**ITEM-2 160 BURWOOD ROAD, CONCORD - PLANNING
PROPOSAL**

EXECUTIVE SUMMARY

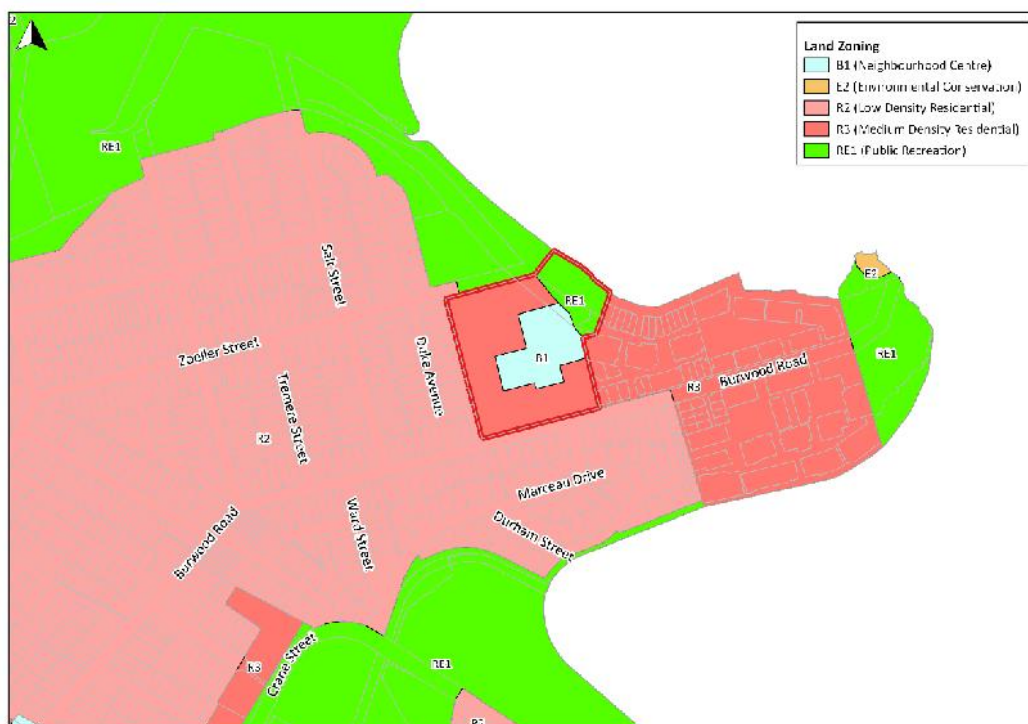
The concept drawings submitted with the Planning Proposal identify approximately 1,300sqm of urban services on the ground floor of Buildings C7 and C8.

Whilst “light industries” are proposed as an additional permitted use, the delivery of this use on the site will be at the discretion of the landowner and this outcome may not eventuate.

The location of the proposed urban services on the ground floor of Buildings C7 and C8 would also mean that light industrial uses are located between and below residential apartments. Even though low impact uses are expected, the industrial premises still require the ability to operate conflict free and have proper vehicular access and circulation. An astute design response would be necessary to ensure that industrial tenancies incorporate high ceilings and adequate vehicle access, circulation and loading space. Light industrial uses should also ideally be located where interfaces with residential uses are minimised. If the configuration and layout is not suitable for urban services/light industrial uses, the success of the space will not be sustainable.

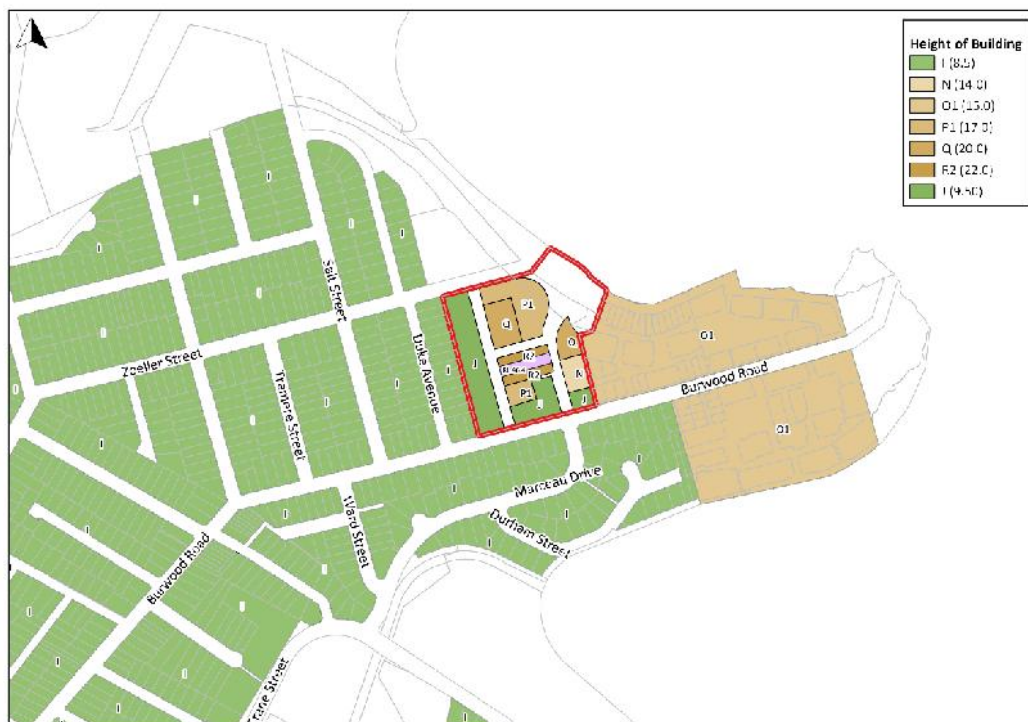
In particular, the nine (9) storey building would reduce views of the Central Roasting Hall from the heritage listed Golf Course and across the wider context including from Cabarita and Prince Edward Park.

The four (4) and five (5) storey buildings proposed in Block 1, along the western edge of the site and the six (6) storey building in Block 3 are adjacent to detached one (1) and two (2) storey houses. The orientation of the building in Block 1 and lack of breaks in the built form, result in the building presenting as a continuous 3 to 5 storey wall that is 160m long.

Various heights are also identified on the proposed maximum height of building map that notionally exceed the height needed to accommodate the proposed number of storeys in the submitted concept plan. For example, 24m heights could potentially accommodate eight (8) storeys instead of seven (7) storeys and the 30m height limit could potentially accommodate ten (10) storeys instead of the nine (9) proposed.

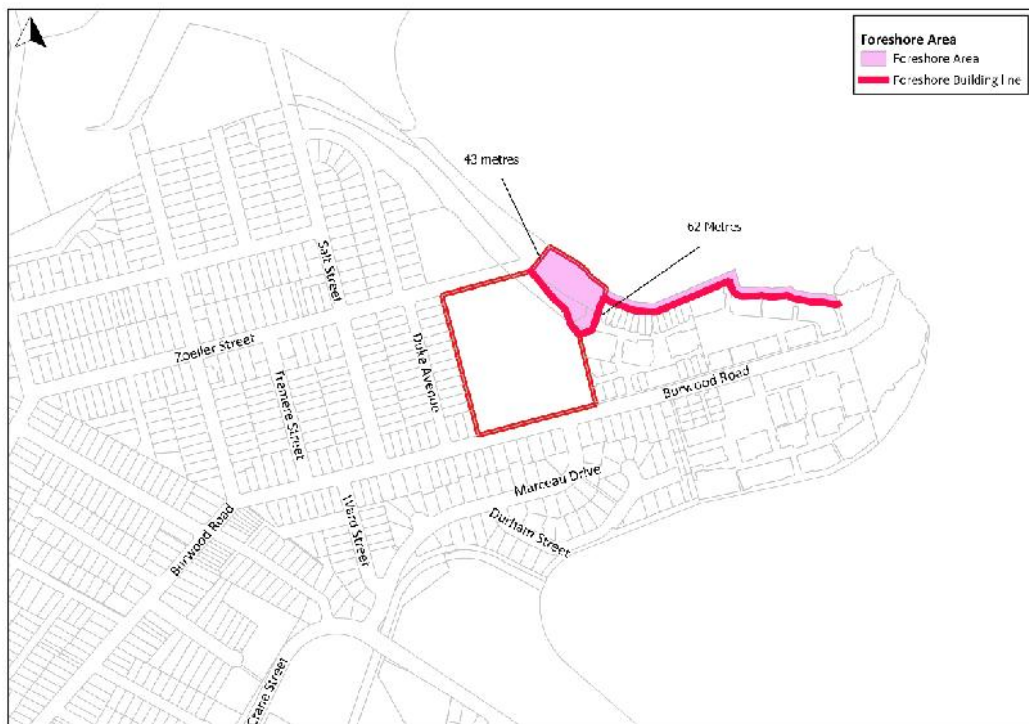
The Concept Plan also defines setbacks with “nominal” dimensions in place of “minimum” dimensions, which suggest that the dimensions may not be fixed. It is recommended that Council prepare a new Development Control Plan for the site that contains minimum setbacks, instead of nominal setbacks from boundaries.

Overall, the street layout identified within the concept plan is supported as it locates the “backs” of apartments facing the “backs” of neighbouring properties and creates defined street frontages internally within the site.

A “nominal” 6 metres setback is proposed along the front (southern) boundary to Burwood Road. The Development Control Plan for Pelican Point, Pelican Quays and Phillips Landing required buildings to be generally set back nine (9) metres, with an absolute minimum of 7.5 metres at any point. To ensure a consistent building alignment to Burwood Road, it is recommended that the front setback to be a minimum of 7.5 metres.
